Airport Road Improvements

**Municipal Class Environmental
Assessment
Airport Road
from 1.0km north of Mayfield Road to
0.6km north of King Street**

STUDY COMMENTS RECEIVED AND STAKEHOLDER ENGAGEMENT

AIRPORT ROAD IMPROVEMENT
PROPERTY IMPACT PLAN
12451 AIRPORT ROAD
(PIN 143480013)

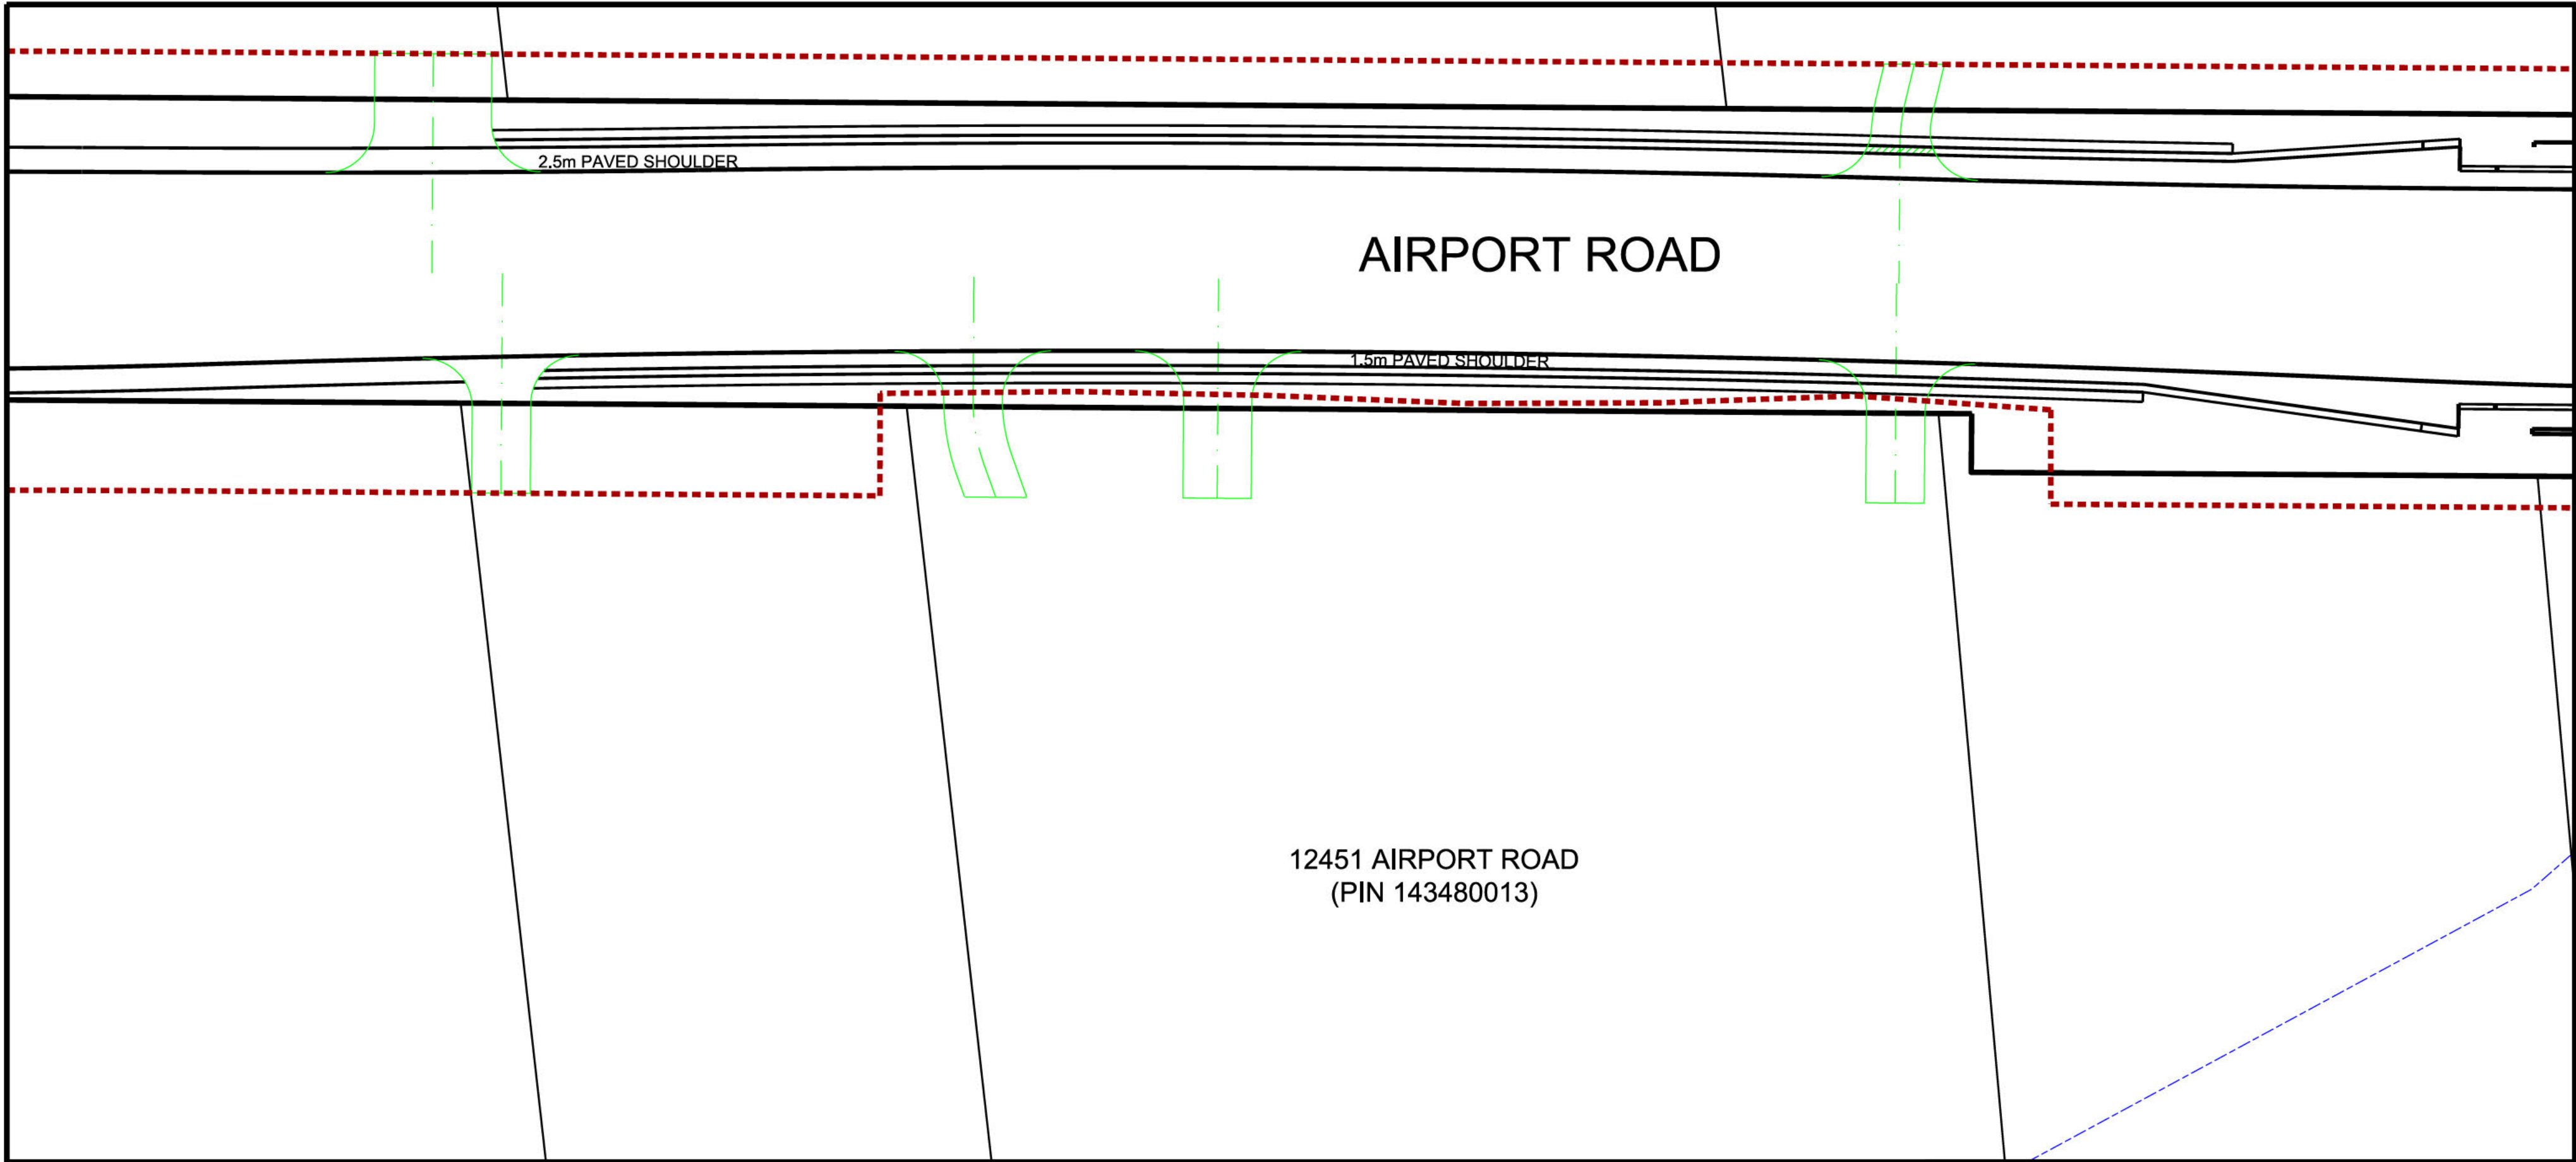
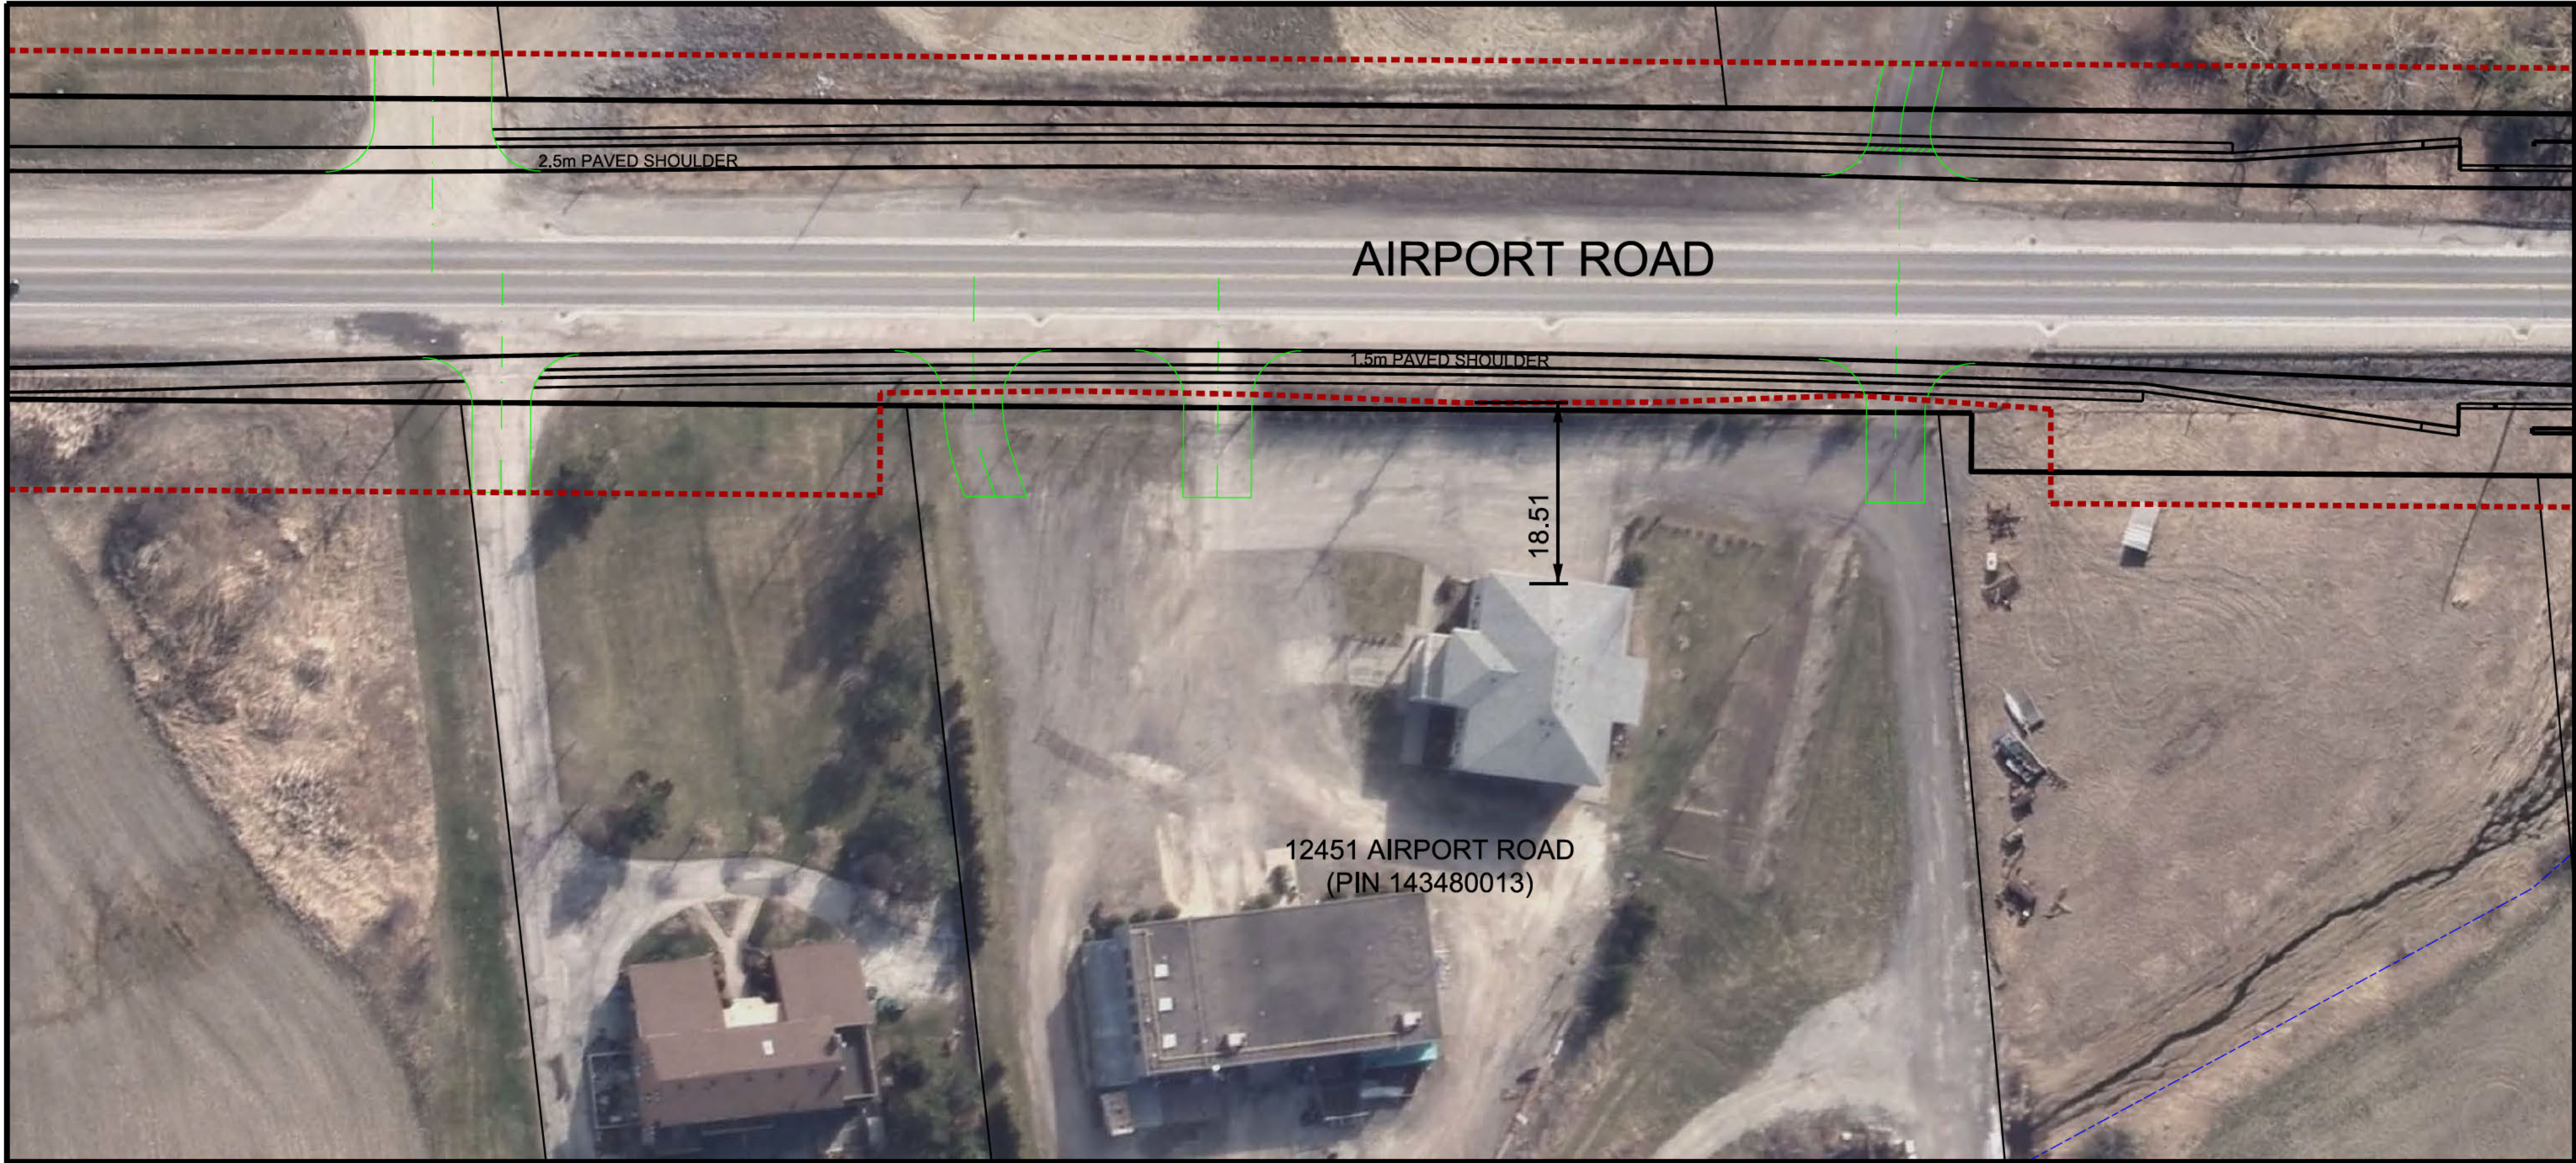
[REDACTED] was happy with the revision to our design that avoids a property requirement at his property. The attached show the updated PIP and a summary of what compromises were made. The roll plan and design plates from IBI already included in the ESR have the original PIP... This should all be documented.
